Product Change Notice (PCN)

Subject: Addition of production sites and material changes for RH850/F1K Series

PCN#: [HPLM-2024-0029]
PC-MCU-A034A/E

Mark Example: R7F7015834AFP-C#BA3 (F1K 144pin)

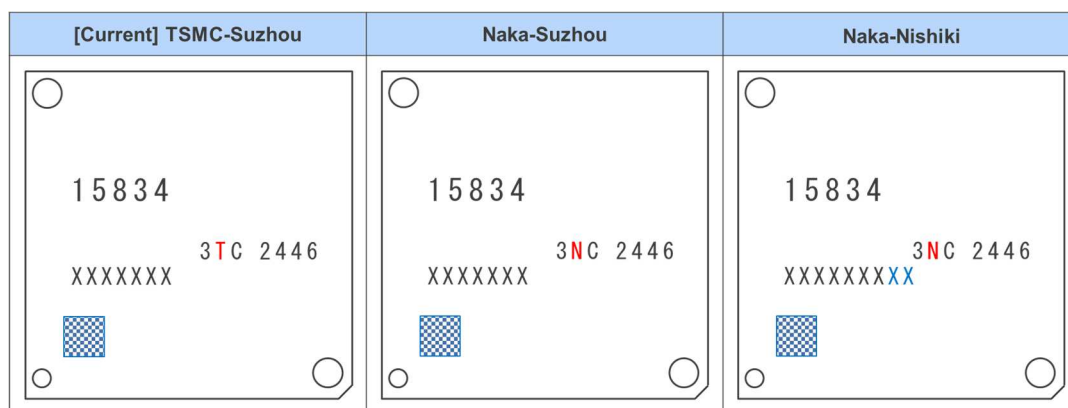
The red character is different between TSMC and Naka products (TSMC: T, Naka: N).

The digit number of Trace Code is different between Suzhou and Nishiki products (Suzhou: 7digits, Nishiki: 9digits).
(The blue characters)

[Current] WP : **TSMC**, Assy/FT : Suzhou

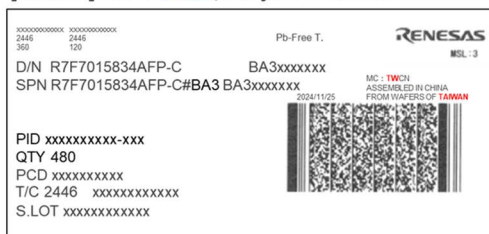
Label Example: R7F7015834AFP-C#BA3 (F1K 144pin)

The red characters are different between TSMC and Naka products.

The blue characters are different between Suzhou and Nishiki products.

[Addition] WP : **Naka**, Assy/FT : Suzhou

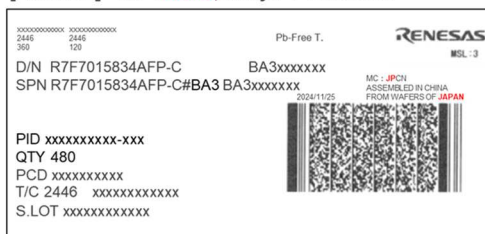
[Addition] WP : **Naka**, Assy/FT : **Nishiki**
